GRADING AND EROSION CONTROL PLAN

WYOMING ESTATES SUBDIVISION EL PASO COUNTY, CO

DRAINAGE, GRADING
AND EROSION
CONTROL COVER

DRAWING NUMBER:
C
SHEET 1

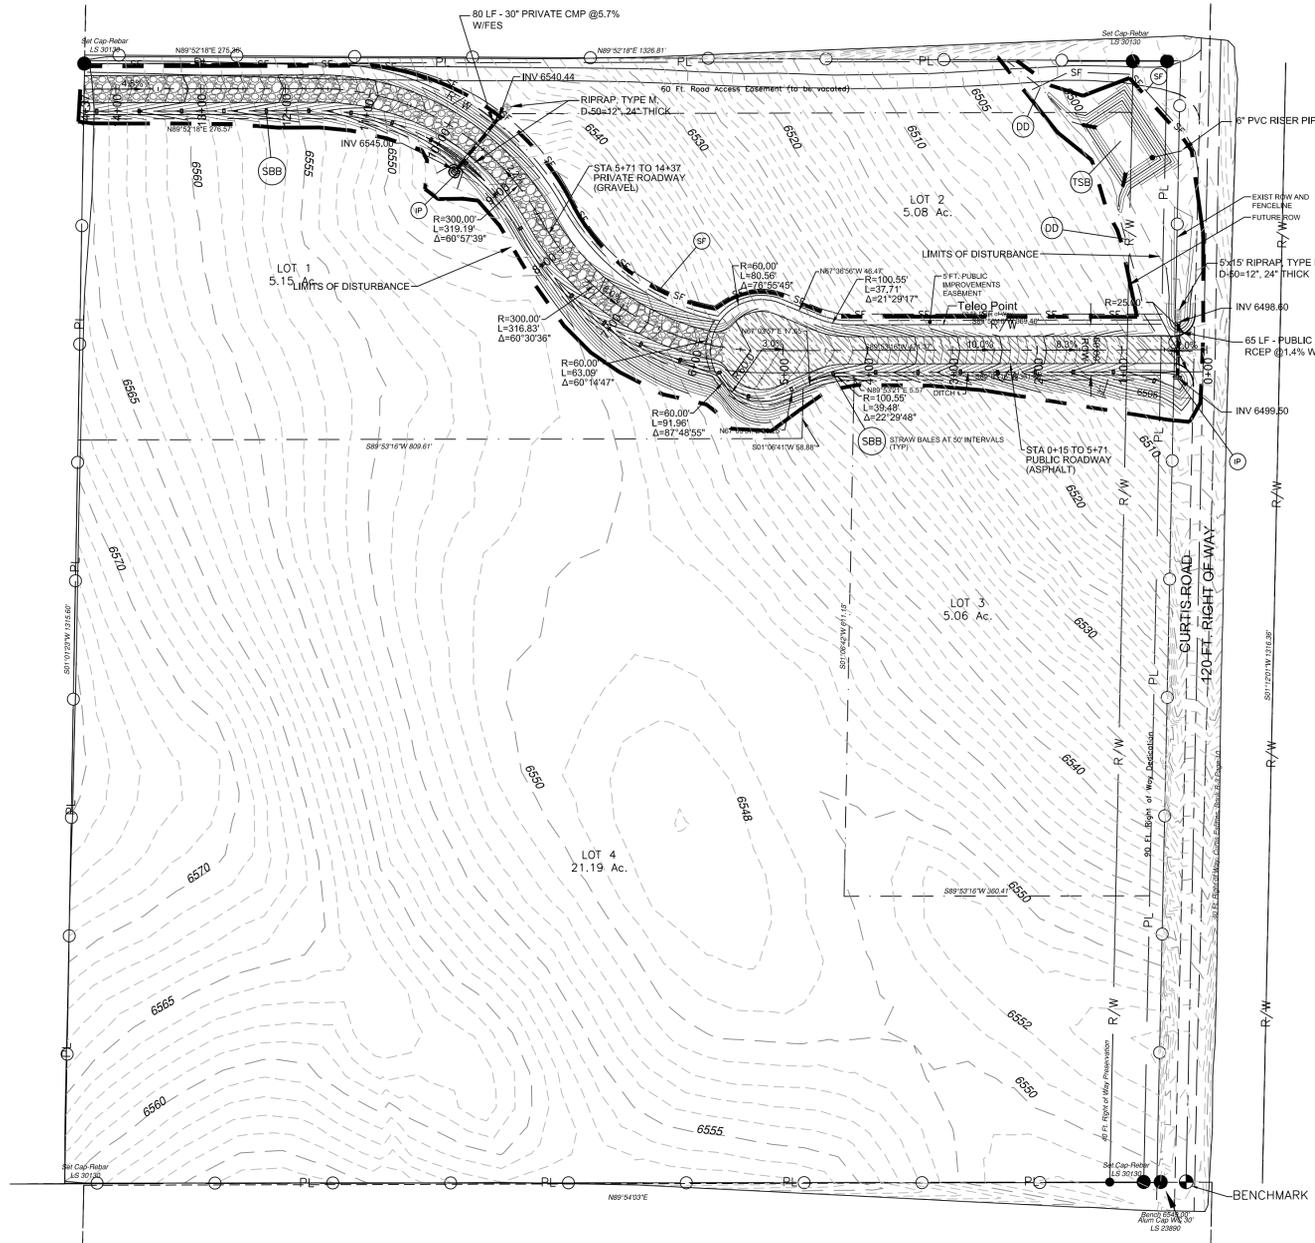
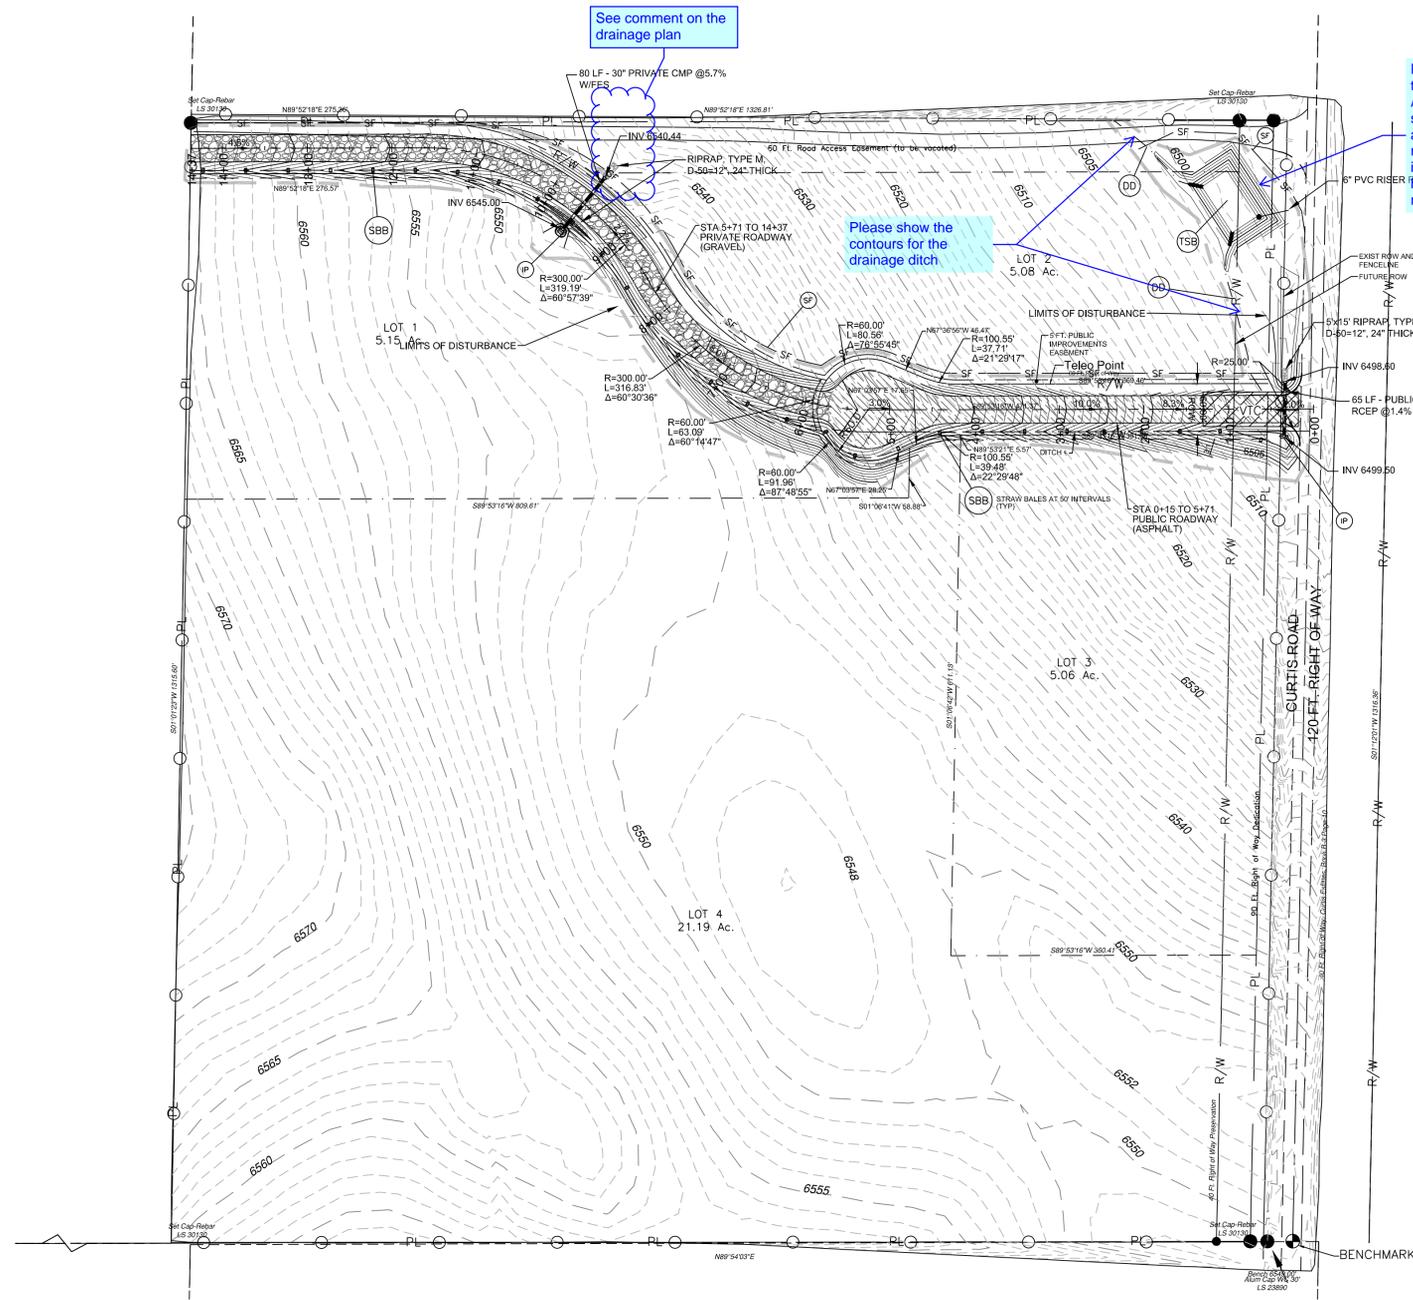
Review 1:
Please remove extra
signature blocks,
typical.
Review 2: Unresolved

DRAWING NUMBER:
C
 SHEET 2

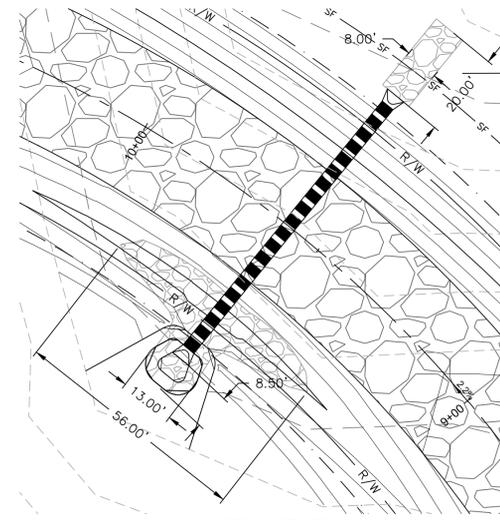
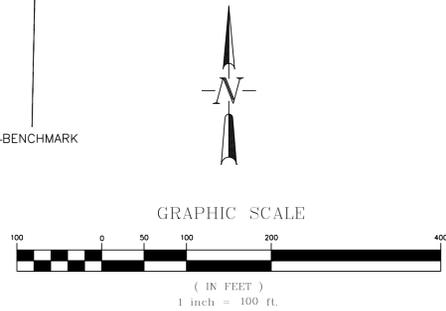
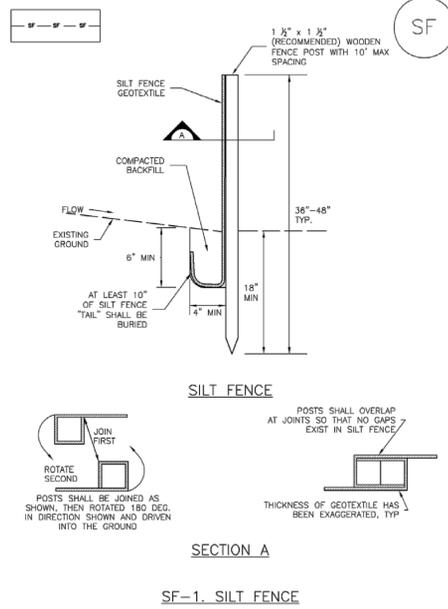
Provide contour labels for the sediment basin. Additionally provide the sediment basin required and provided volume and riser pipe construction information such as the pipe diameter per the review 1 comment.

Please show the contours for the drainage ditch

See comment on the drainage plan
